Planning Commission Meeting

November 10, 2020 6:00 PM

Justin Honore submitted a request for site plan review to construct a new single--family dwelling with a detached garage at 236 Mt. Zion Road, Parcel Identification Number 14 0094-0009-011-6. The property is zoned R--1, One-Family Detached and is subject to the Neighborhood Conservation Area of the Architectural Design Standards.

Title: Site Plan Review-236 Mt Zion Road Revisions

① Garage & Porch Plan
1/4" = 1'-0"

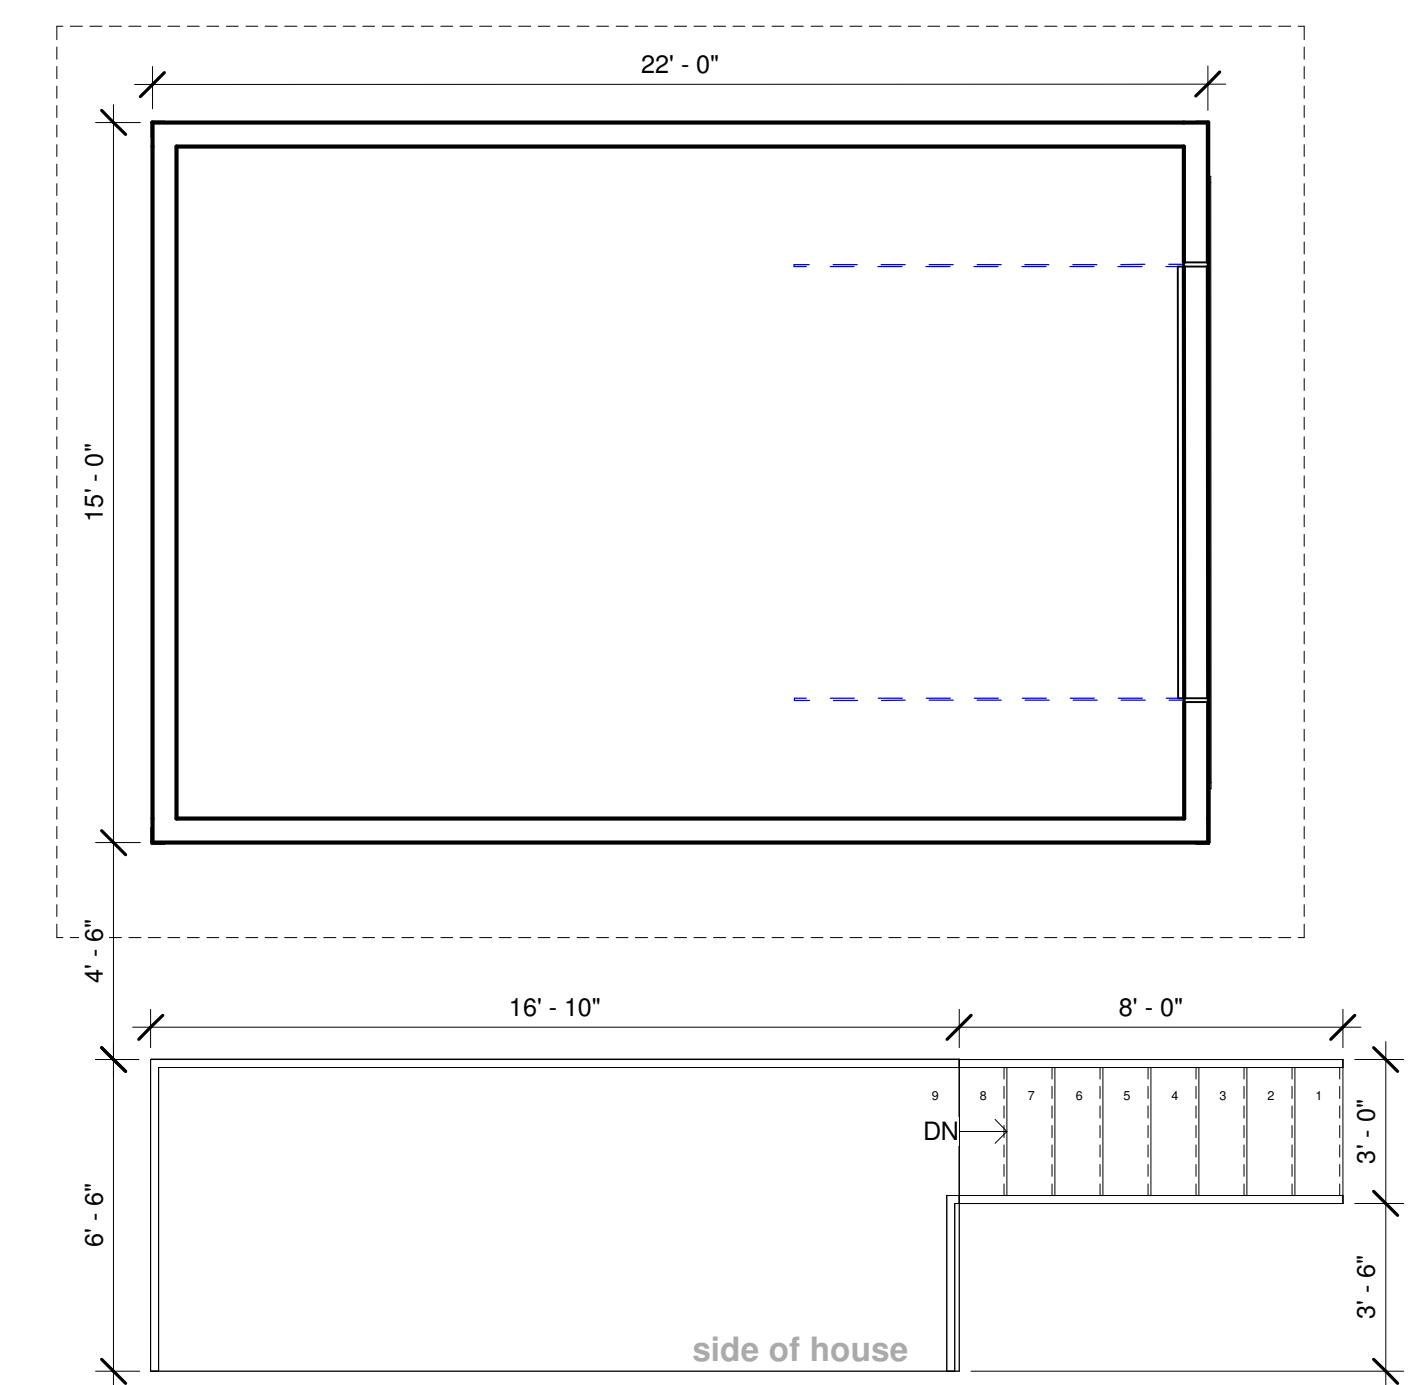
- A dry pit/standpipe design is shown on the site plan.
- (2) Site and building sections. Schematic or illustrative sections shall be drawn to .scale of 1" = 8' or larger, necessary to understand the relationship of internal building elevations to adjacent site elevations.

- The building elevations will be reviewed by the Design Review Committee for compliance with the Architectural Design Standards. No detail for the garage has been provided.

- The building elevations will be reviewed by the Design Review Committee for compliance with the Architectural Design Standards. No detail for the garage has been provided.

- Section Provided on sheet A7 detail 6 -Site Section

- New garage details on sheet A7
